Project update

September 27, 2010

Replace US 101 Bridge Design Refinement

Option 1: 2' above 100 year flood elevation

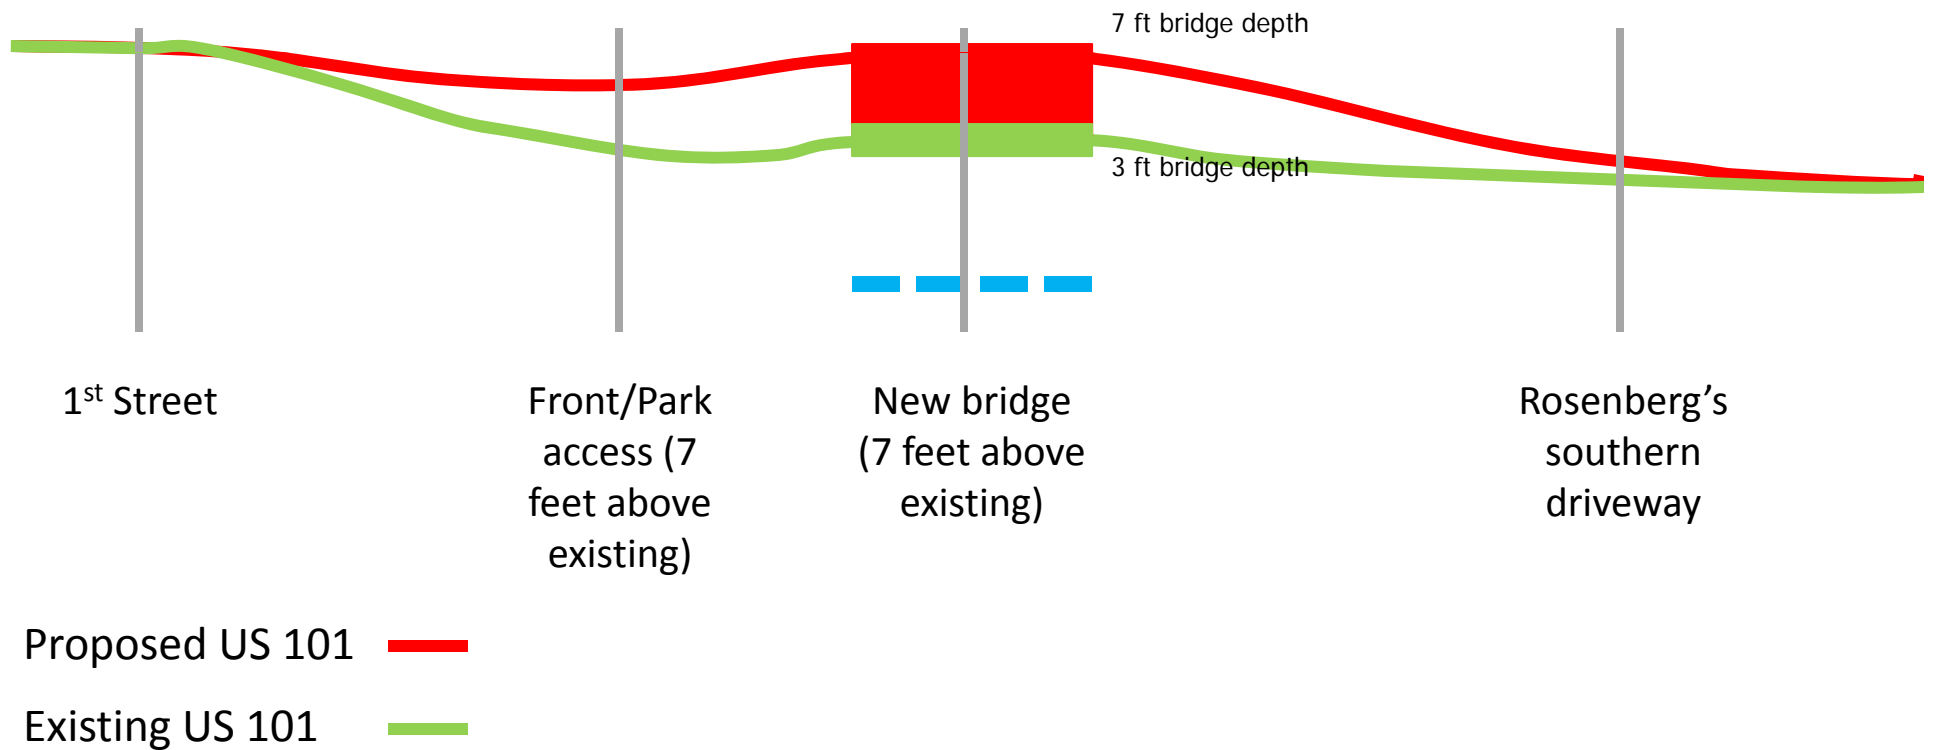
Update with new profiles

Option 2: Within 100 year flood elevation

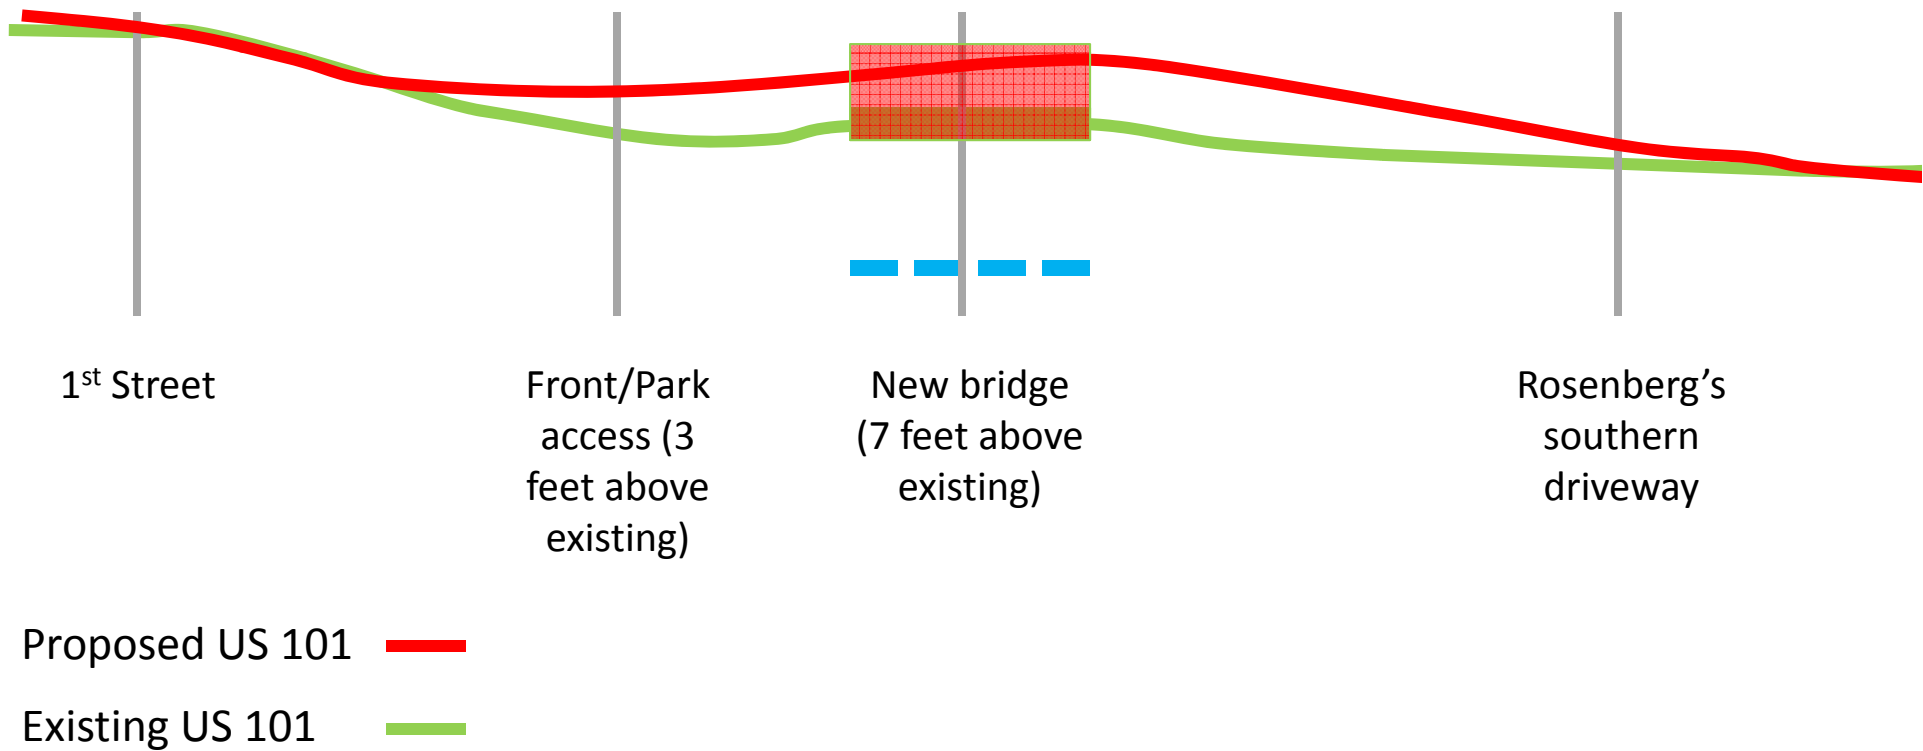
KH3 **Update with new profiles**
Kristin Hull, 9/21/2010
